2004 Ford Mustang V8-4.6L SOHC VIN X
Vehicle > Technical Service Bulletins

BODY - HOOD SCOOP RATTLES

03-22-1

11/10/03

Figure 1

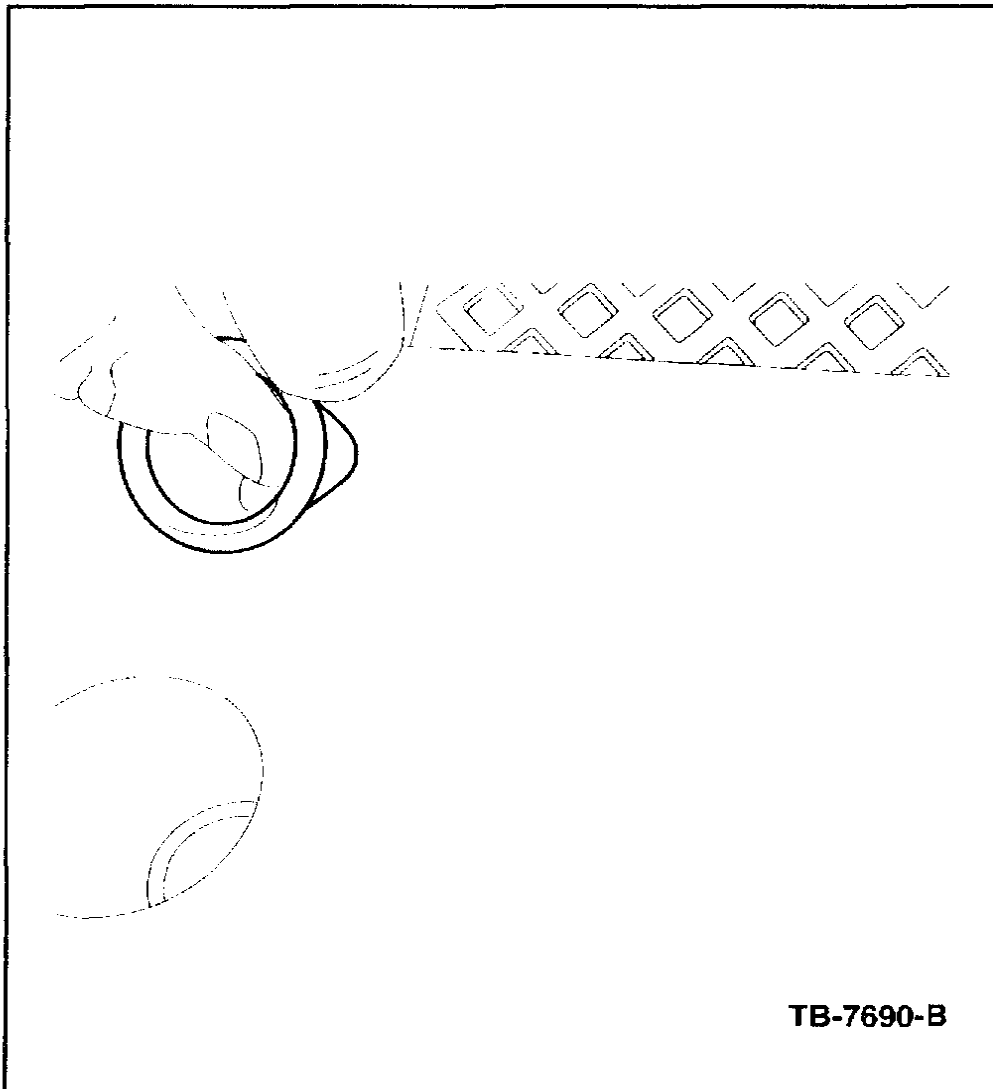
3. Remove the four (4) isolators by grasping with your fingers and pulling up and towards the center of the isolator (Figure 1).

Figure 2

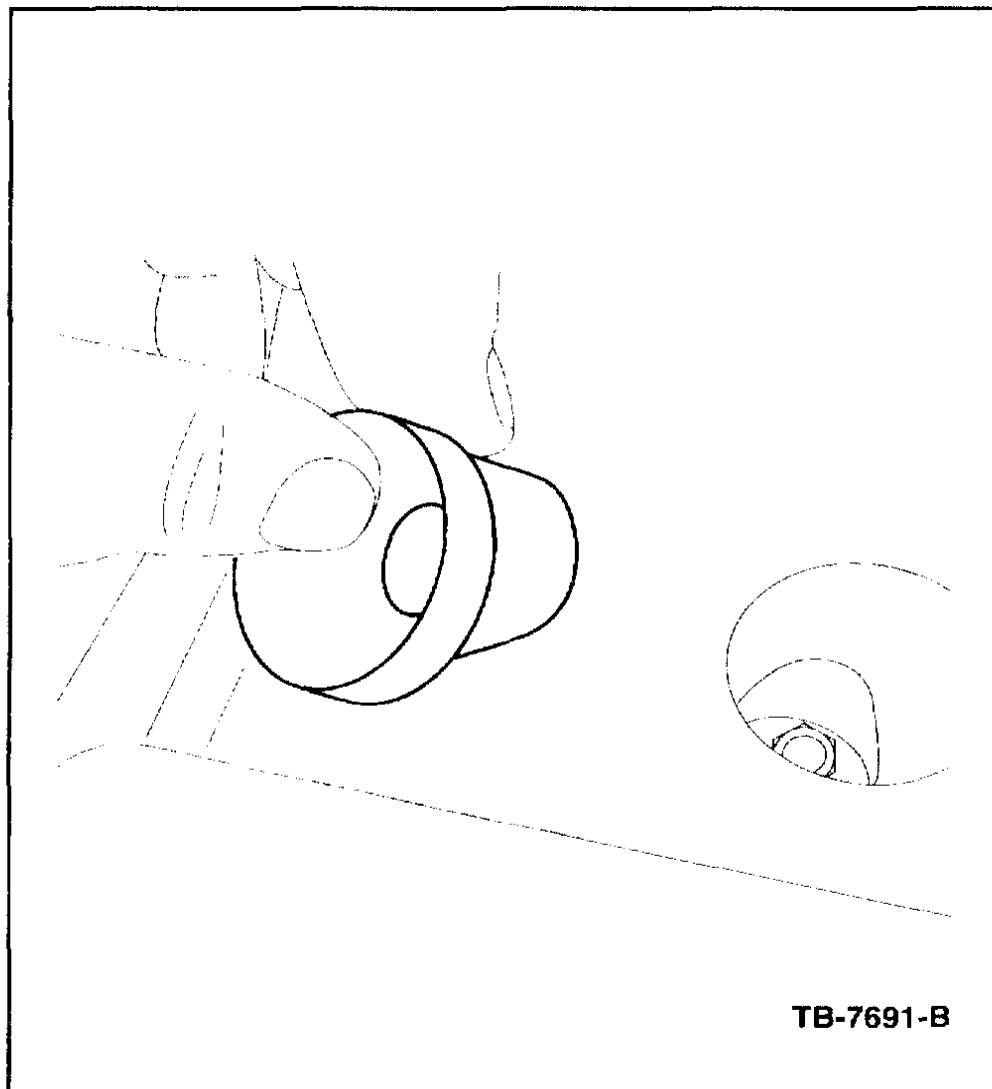
4. Install new Isolators (2L7Z-9P686-M) by setting the isolator in the hole at an angle (Figure 2) and pressing down, while working the outer edge of the isolator down into the hole with your fingers.
